**METROPOLITAN GOVERNMENT OF NASHVILLE AND DAVIDSON COUNTY**

**STAFF RECOMMENDATION**  
**208 Mayfair Road**  
**September 21, 2016**

**Application:** New construction—addition; Setback determination  
**District:** Cherokee Park Neighborhood Conservation Zoning Overlay  
**Council District:** 24  
**Map and Parcel Number:** 10312020100  
**Applicant:** Brian Layton  
**Project Lead:** Melissa Baldock, melissa.baldock@nashville.gov

**Description of Project:** Application is to construct a screen porch at the rear of the building that requires a setback determination.

Figure 3. The site maps showing the angled rear lot line.

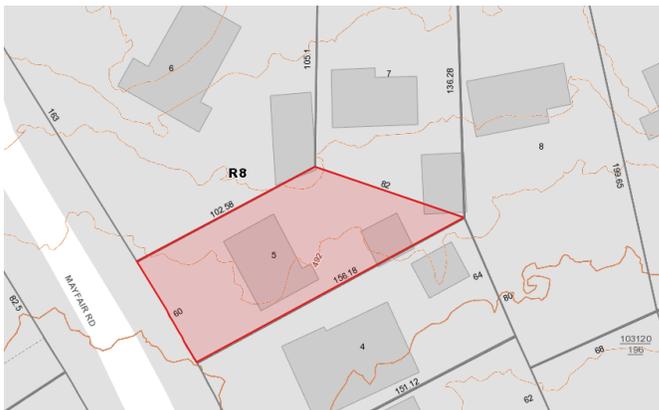
**Setback & Rhythm of Spacing:** The proposed screen porch does require a rear setback determination. Base zoning requires a five foot (5') side setback and a twenty foot (20') rear setback. The proposed addition meets the required side setback, but will be between eight feet, ten inches and nineteen feet (8'10" - 19') from the rear property line. The existing rear property line is angled so that the rear yard is significantly truncated on one side (Figure 3). This significantly reduces the buildable area of the rear yard, particularly on the north side of the lot. If the rear property line was not angled but straight like is typical in this neighborhood, the screen porch would more than meet the required twenty foot (20') rear setback. Staff finds the proposed rear setback to be appropriate because of the peculiarities of the site and because of the modest scale of the proposed addition. Staff therefore finds that the proposed addition meets Sections II.B.1.c. and II.B.2. of the design guidelines.

1 SITE PLAN  
A-01

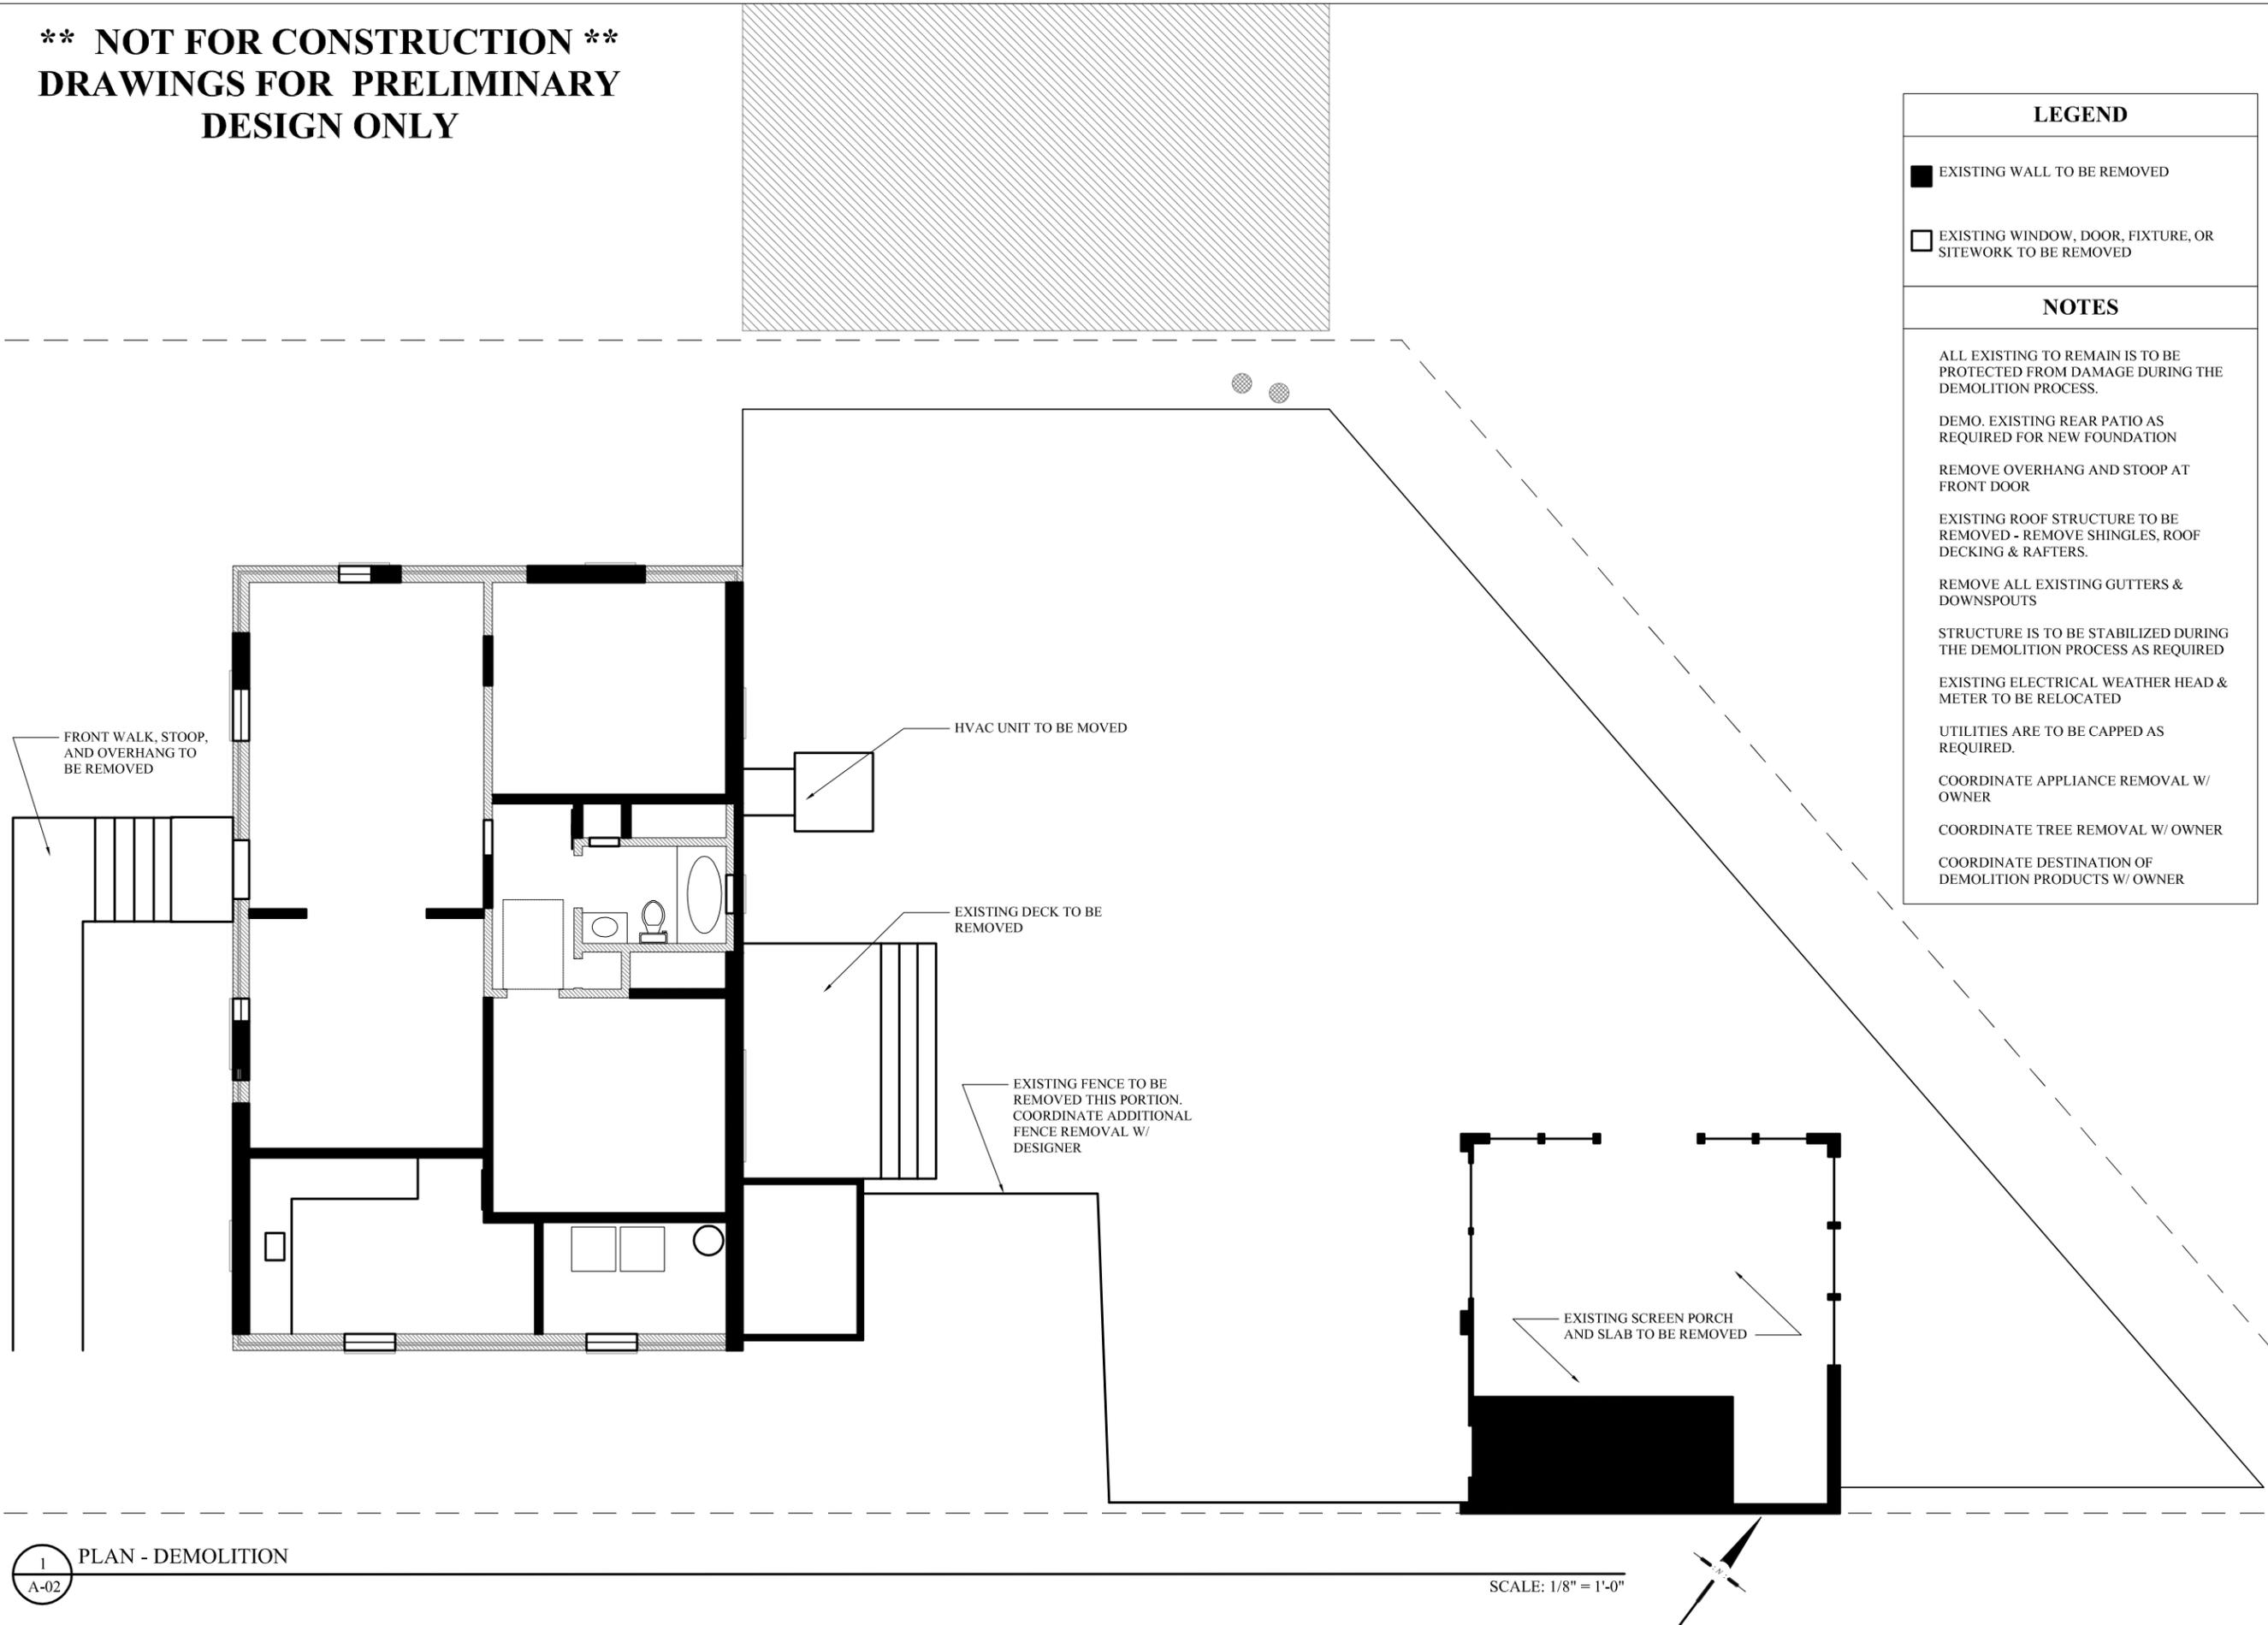
**Height & Scale:** The proposed rear screen porch will be thirteen feet (13') wide and eighteen feet, nine inches (18'9") deep, with a square footage of approximately two hundred and forty-four square feet (244 sq. ft.). It will be one story, with an eave height of ten feet, three inches (10'3") and a ridge height of seventeen feet, nine inches (17'9"), both of which are lower than the eave and ridge heights on the existing house. The height and scale of the proposed screen porch is relatively modest. Staff finds that it meets Sections II.B.1.a., II.B.1.b., and II.B.2. of the design guidelines.
